PLANNING DEPARTMENT DESIGN VARIANCE STAFF ANALYSIS

CASE NO: 2024-0089

REQUEST: Variance from AMC 21.05.040A.3.e. to not require L2 buffer landscaping along the east lot line for an adult care facility in the RO (residential office) district

LOCATION: Russian Jack Subdivision, Tract A-1, Lot 2-B

SITE PLAN
 A11.1

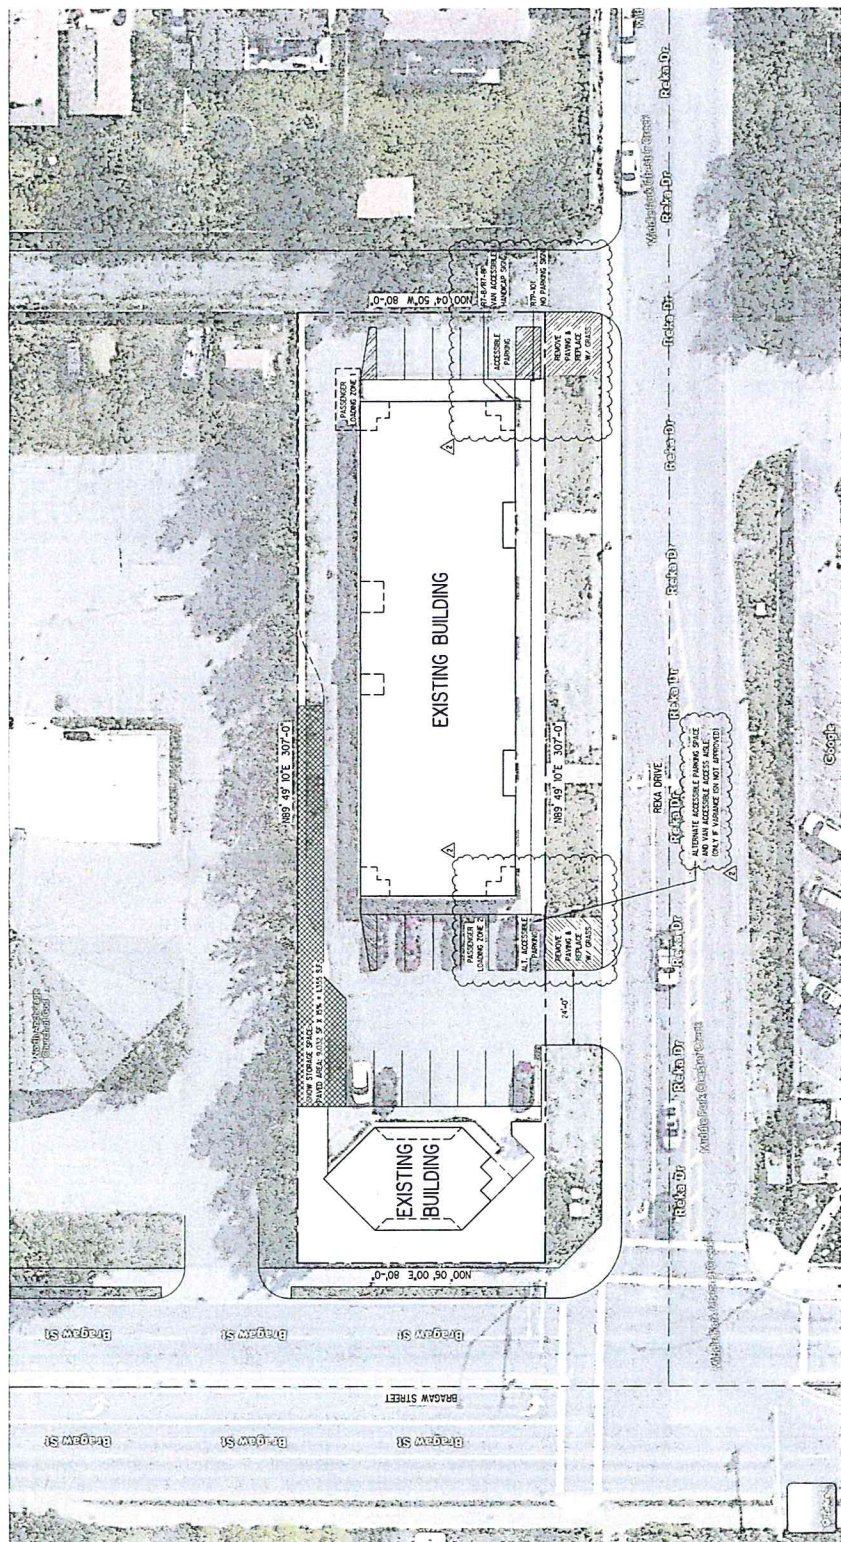
We are requesting a variance to not be required to install the landscaping along the alley, because we would lose a significant amount of the parking for the site which would impact the functionality of the building.

- The subject lot is R0 zoning.
- The lot across the alley to the east is R3 zoning.
- For the Adult Care (adult daycare) use, the subject lot would require L2 buffer landscaping along the east property line (alley side).
- The R3 zoned lot across the alley has a solid 6-foot-high cedar fence/ shed/garage, and natural vegetation along the alley (see attached photo).
- There are two buildings on the subject property, with parking in between, and existing 90-degree parking against the alley. The parking for this "Adult Daycare" tenant would be on the alley-side, with a drop-off at the north side of the building and another drop-off at the west side of the building in the existing parking. Accessible routes would be created on both ends of the building.

Response: We are proposing to add an Accessible space and accessible route to both units in this structure. This parking space is currently proposed to be in the alley parking row and is the closest adjacent space to our Adult Daycare Use front entry. This parking space will need to be relocated if the

variance is not accepted to the parking lot between buildings, which would cause the property to lose another parking space because of the adjacent "no parking" space.

The Department recommends APPROVAL of the variance from AMC 21.05.040A.3.e. to not require L2 buffer landscaping along the east lot boundary for an adult care facility in the RO district, subject to:
